PREVOST

WARRANTY BULLETIN

WB15-10

DATE :	APRIL 2015	SECTION :	01 - Engine
EXPIRATION:	APRIL 2017		
SUBJECT :	ENGINE OIL FILL FLEXIBLE TUBE INSPECTION AND REPLACEMENT

Figure 2

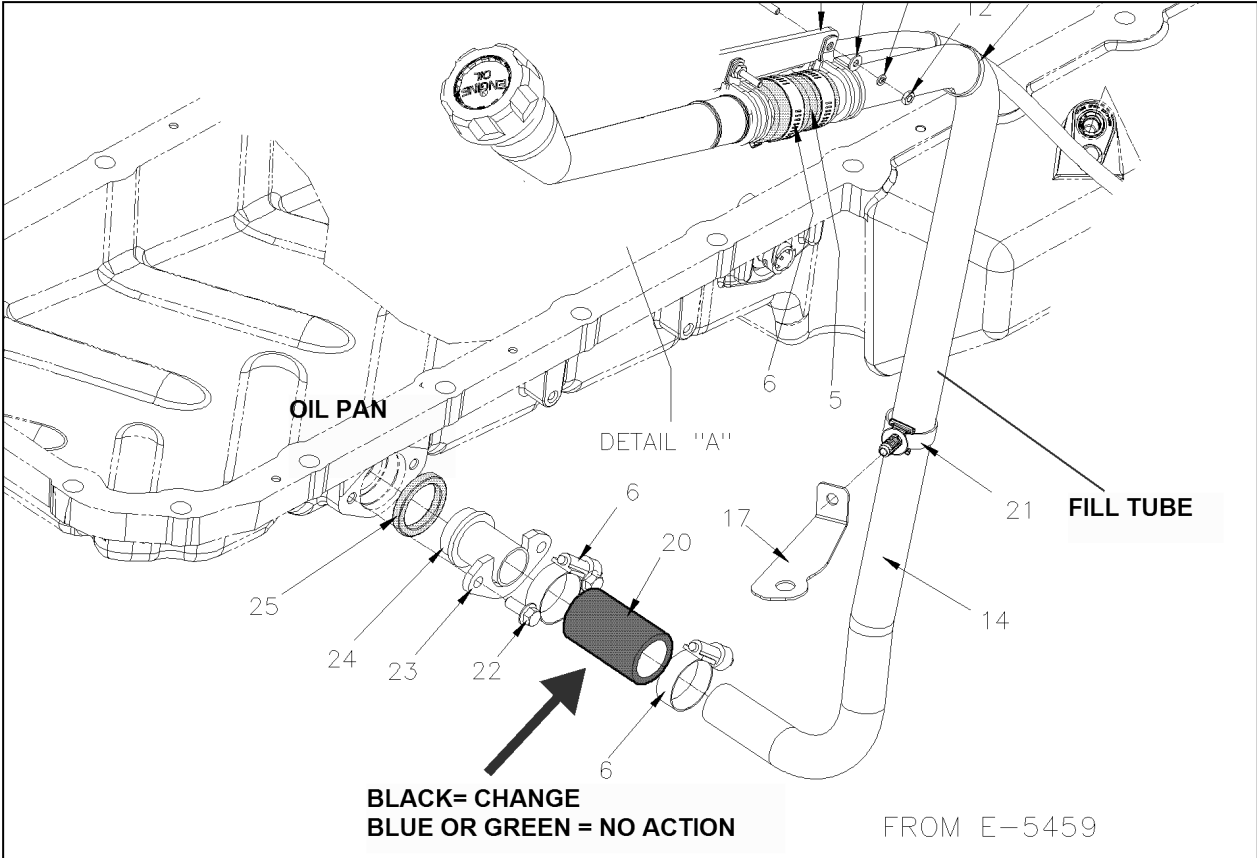
On the vehicles affected by this bulletin, inspect the lower oil fill tube flexible tube. If it is made of black material (EDPM), replace tube. Green and blue silicone hoses are accepted.

- A. Open curb side engine compartment door. (Item 2, Fig. 1)
- B. Visually inspect the lowest section of the oil fill tube. (Fig. 2) The hose connecting the steel tube to the oil pan should be green or blue. (Fig 3 & 4)
- C. If hose is black, perform replacement according to Step **B** below. Otherwise, this is the end of the bulletin.

- 2) Using two mobile column lifts, jack vehicle about 38 cm (15 in) by drive axle to allow oil to move to the forward section of the oil pan.
- 3) Use a suitable container to collect any remaining oil that may drip while performing replacement.
- 4) Perform tube removal by undoing the two clamps. (Fig. 2) Dispose of tube according to regulations.
- 5) Install new tube 012933. Tighten clamps to 3,4 N-m (30 lbf-in).
- 6) Apply a torque seal of different color from the original seal to clearly mark change.
- 7) Lower vehicle. Confirm proper operation. Confirm installation is oil tight.
